<b>Docket Number:</b>	00-AFC-14C
<b>Project Title:</b>	El Segundo Power Redevelopment Project Compliance
<b>TN #:</b>	200464
<b>Document Title:</b>	Applicant's Responses to Data Requests in Set One (#1-83)
<b>Description:</b>	N/A
<b>Filer:</b>	Dee Hutchinson
<b>Organization:</b>	Locke Lord LLP
<b>Submitter Role:</b>	Applicant's Representative
<b>Submission Date:</b>	9/12/2013 3:54:19 PM
<b>Docketed Date:</b>	9/12/2013

Re: El Segundo Energy Center Petition to Amend (00-AFC-014C)  
Applicant's Responses to Data Requests in Set One (#1-83)

**Data Responses, Set 1  
(Response To Data Requests 1 to 83)**

## El Segundo Power Facility Modification

FIGURE DR1-1  
3-D El Segundo Power  
Facility Modification  
El Segundo Energy Center

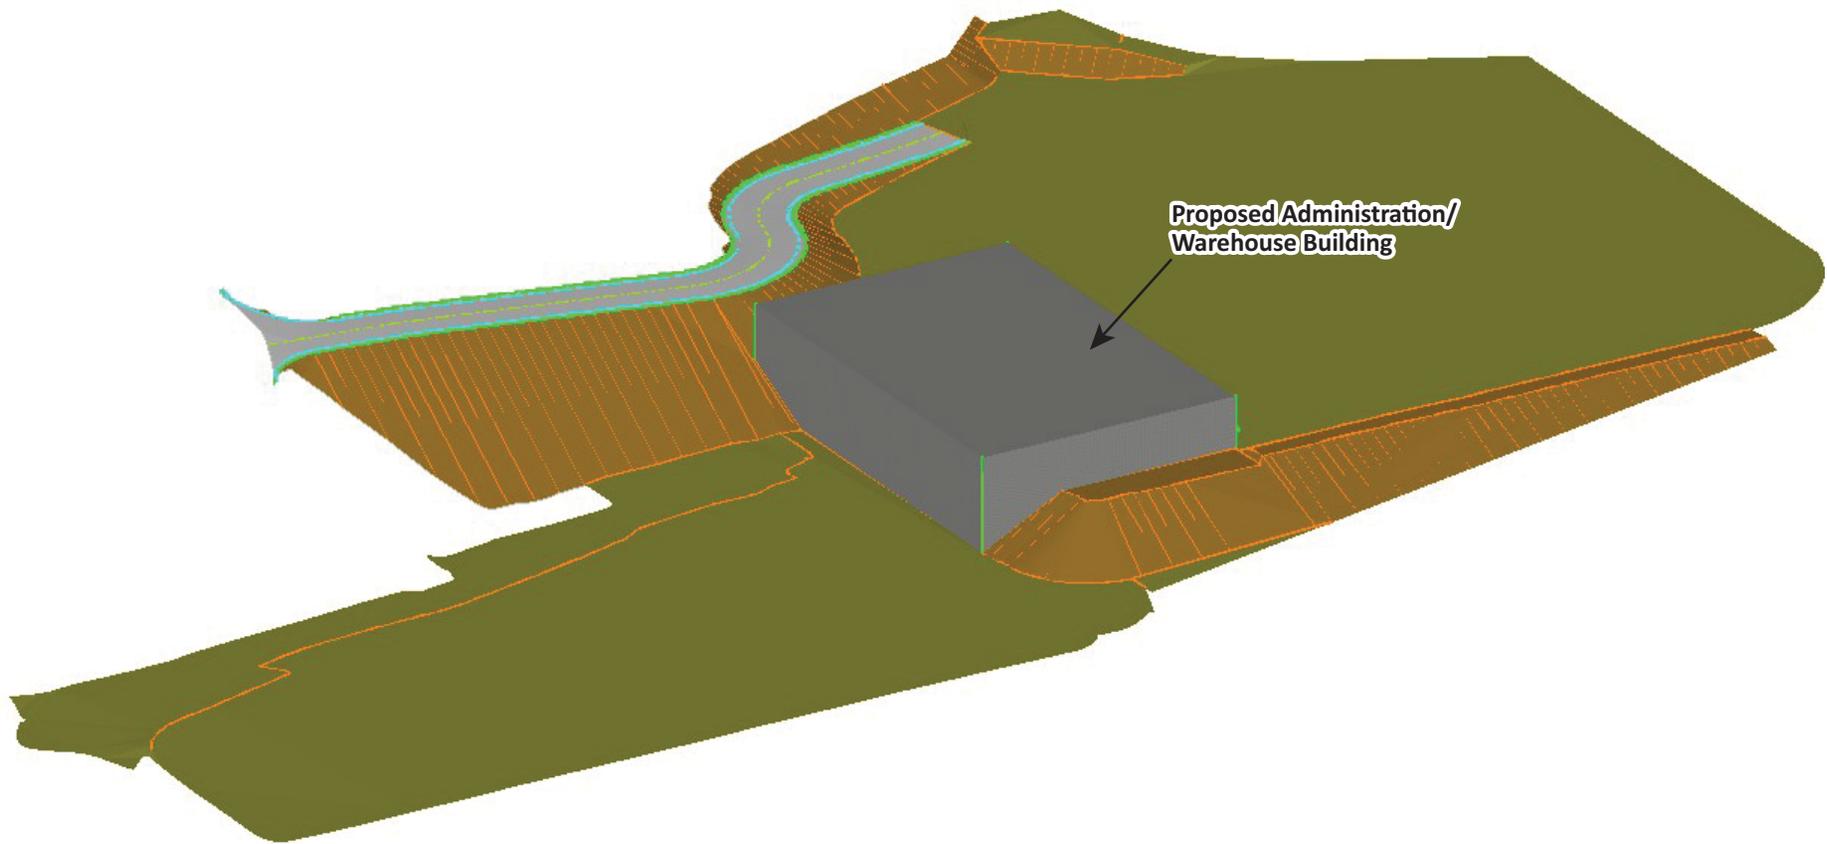
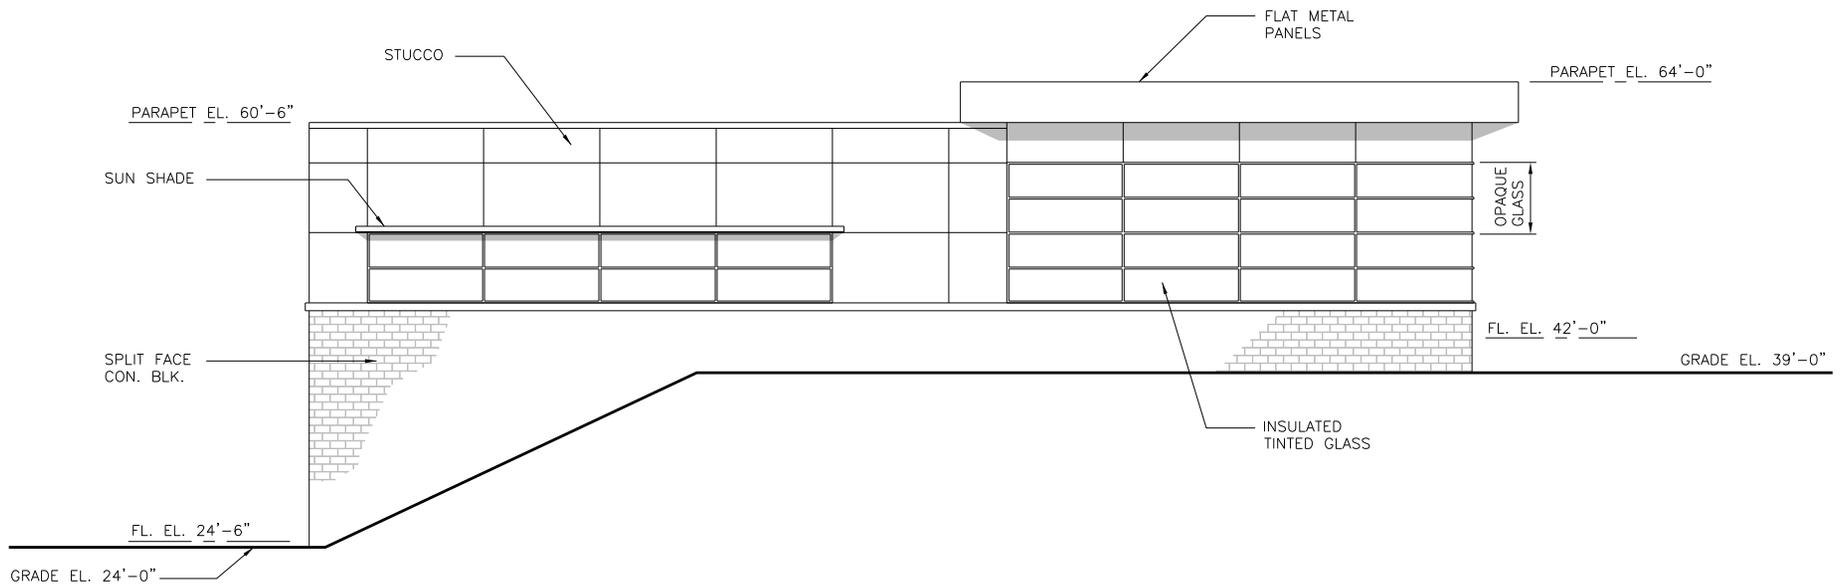
1. Please provide a site schematic/volumetric drawing of the facilities to be constructed for units 9, 10, 11 and 12 with associated facilities.

This information is provided in PTA Figures 1-2a and 1-2b *Site Plan, Sheets 1 & 2* for the new equipment, and in Table 2-1 *Dimensions of Significant Structures*. See attached Figure DR1-1, which provides a three-dimensional rendering of the proposed modification.
